UNITED STATES PATENT AND TRADEMARK OFFICE

10/790,551

Rudolf Neumann

Office Action Summary

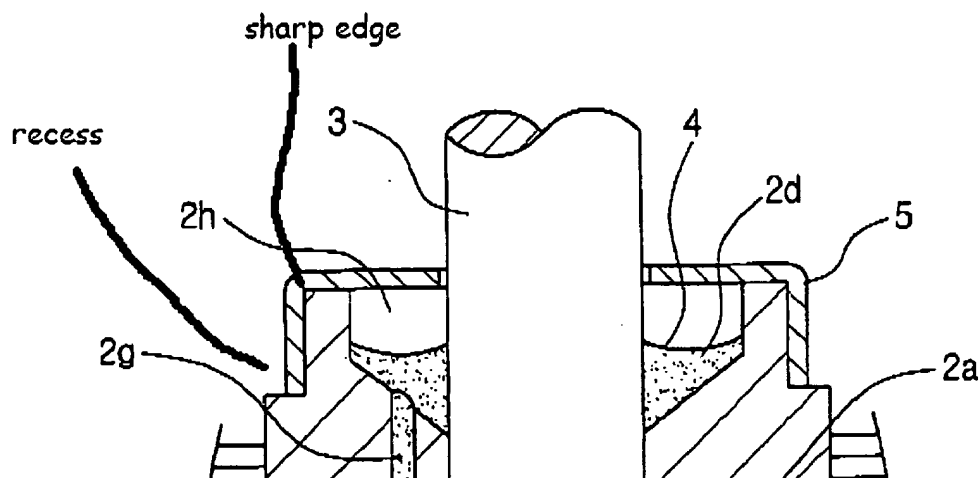
Kishi discloses a hydrodynamic bearing and motor system comprising:

- a shaft (3)

- a bearing sleeve (2), said bearing sleeve having an inner cylindrical bore, the shaft inserted into the bore.

- a bearing gap (2a, 2b) formed between the shaft and bearing sleeve, filled with lubricating oil (4)

- a shield (5) enclosing the bearing sleeve

wherein the bearing sleeve further comprises a recess having a sharp edge and where the shield is secured to the bearing sleeve by being pressed against the sharp edge of the recess.

Regarding claims 3 and 10, at least one bearing element (2i) is mounted on the shaft.

Regarding claims 4 and 11, the bearing and spindle motor have a lubricating oil reservoir (2d, 2e, 2f), and the shield is secured within the recess of the bearing sleeve at a position that is distanced from the lubricating oil reservoir.

Regarding claims 5 and 12, the shield is secured at a position on said end surface of the bearing sleeve that is distanced from the bearing gap, and the shield does not contact the lubricating oil.
